**BOARD OF ZONING ADJUSTMENT
STAFF REPORT****Date: May 6, 2013****CASE NUMBER**

5826

Lyn Manz-Walters

2406 Prichard Avenue West
(North side of Prichard Avenue West, 200'+ East of
Mobile Street)

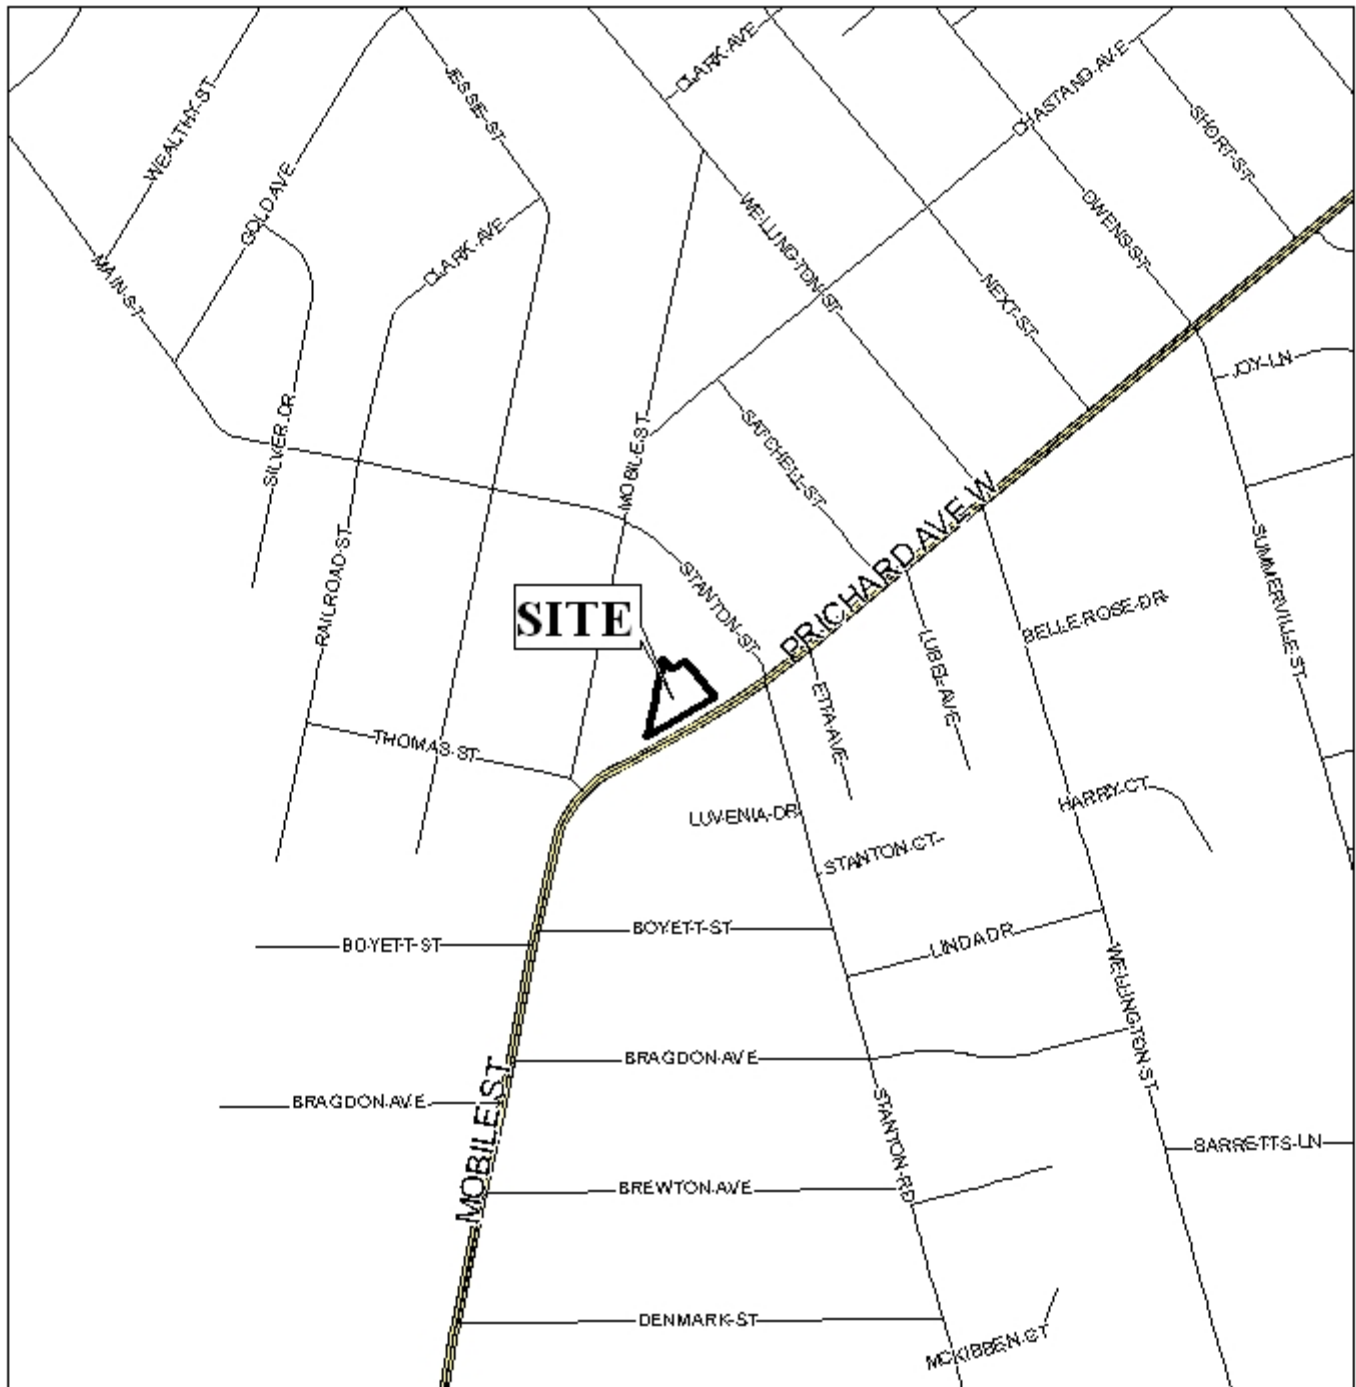
Regarding the proposed site improvements, the proposed carport structure will meet all required setbacks. The gravel drive, maneuvering and parking area will be compatible with neighborhood (though a concrete or asphalt driveway apron may be required by Engineering), though storm water detention facilities may still be required for the site, and parking bumpers or landscape timbers should be provided to prevent vehicles from driving onto adjacent landscape areas. The proposed privacy fence and gate should be set back from Prichard Avenue West a minimum of 25-feet, to ensure adequate visibility (though the existing homes are within five (5) feet of the right-of-way).

Regarding the proposed trees, the site plan should be revised to place the proposed understory trees at a point near the right-of-way, midway between each dwelling, so that access between the dwellings can be preserved for fire-safety reasons. The proposed heritage trees located on each side of the property should be live oaks, if they will be planted within 15-feet of overhead power lines. The proposed understory trees should be crepe myrtles, if they will be planted within 15-feet of overhead power lines.

No lighting of the site is depicted on the site plan. As the proposed use will be rental units, any site lighting must comply with Section 64-4.A.2. and Section 64-6.A.3.c.the Zoning Ordinance, thus no light should shine off of the site.

Finally, no sidewalk is proposed by the applicant. Due to the fact that the existing dwellings are so close to the right-of-way, providing a sidewalk would more clearly delineate where pedestrians can walk without trespassing on the property.

- 1) Revision of the site plan to depict the 6-foot privacy fence and gates to be a minimum of 25-feet from the right-of-way of Prichard Avenue West;
- 2) Revision of the site plan to relocate the proposed understory trees at a point near the right-of-way, midway between each dwelling, so that access between the dwellings can be preserved for fire-safety reasons;

- 3) Revision of the site plan to include a note stating that any heritage tree planted within 15-feet of an overhead power line must be a live oak, and any understory tree planted within 15-feet of an overhead power line must be a crepe myrtle;

- 4) Revision of the site plan to show parking bumpers or landscape timbers around the gravel parking and maneuvering area;
- 5) Revision of the site plan to depict a sidewalk along the right-of-way of Prichard Avenue West;

- 6) Placement of a note on the site plan stating that site lighting must comply with Section 64-4.A.2. and Section 64-6.A.3.c.the Zoning Ordinance;
- 7) Compliance with Engineering comments (*The Engineering Department did not receive any request to review an alternate surface. Any development, whether gravel or paved, would require a Land Disturbance Permit and would be reviewed for conformance to the Storm Water Management and Flood Control Ordinance prior to any construction of proposed site work.*);
